Office of Transit and Active Transportation

Bus Emergency Exits – Examples

Aisle Does Not Meet Minimum Clear Width

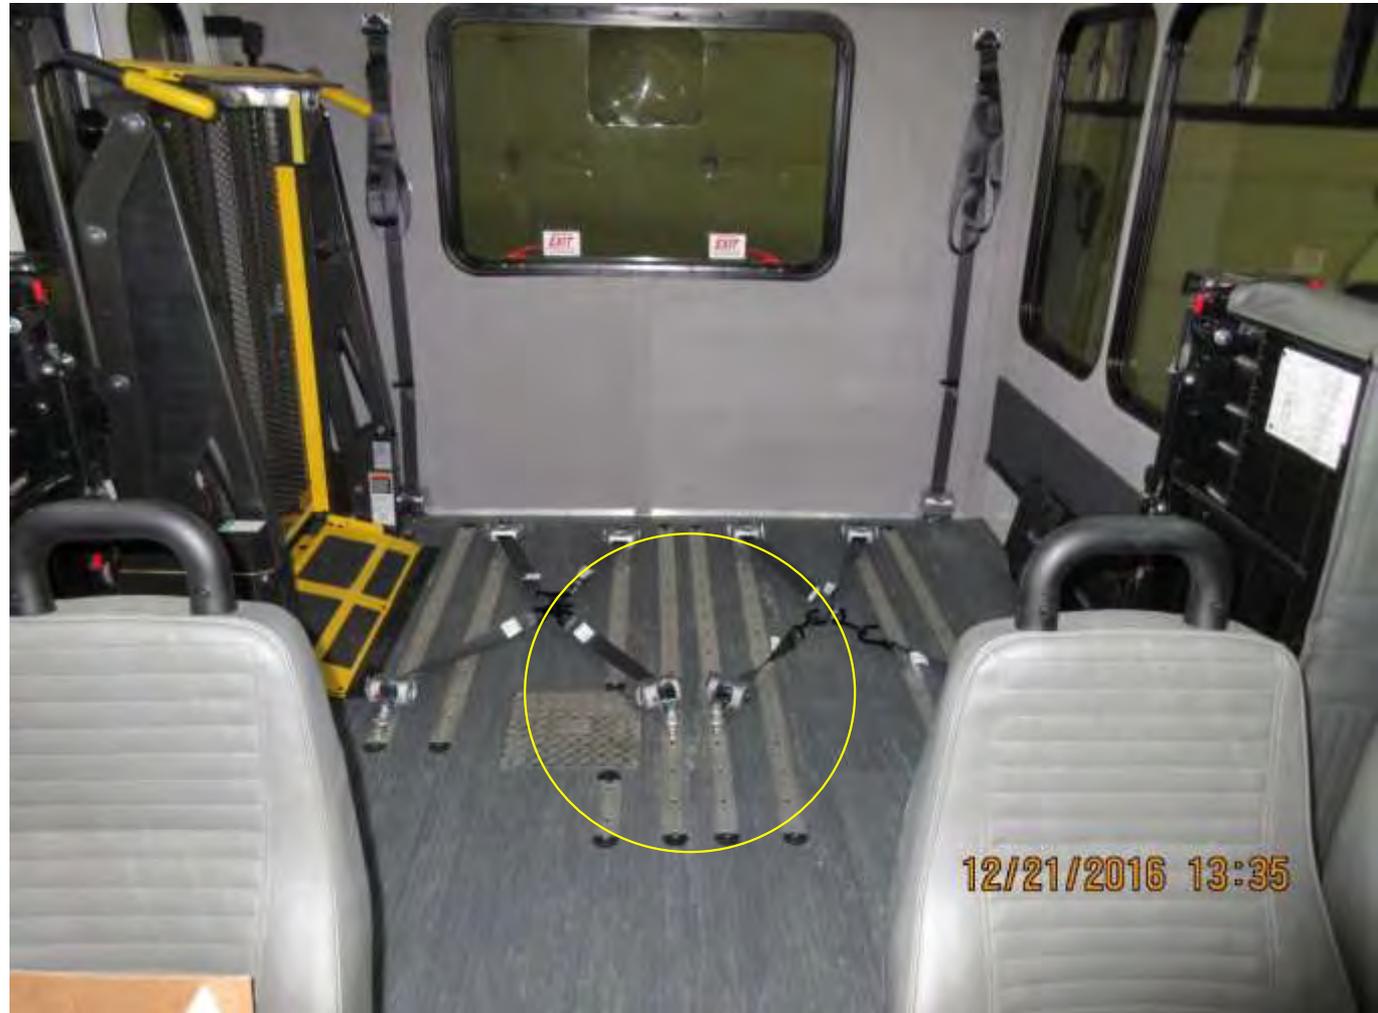
- Aisle width in wheelchair area next to the lift does not meet the minimum width of 12" – obstructed access to rear emergency exit window
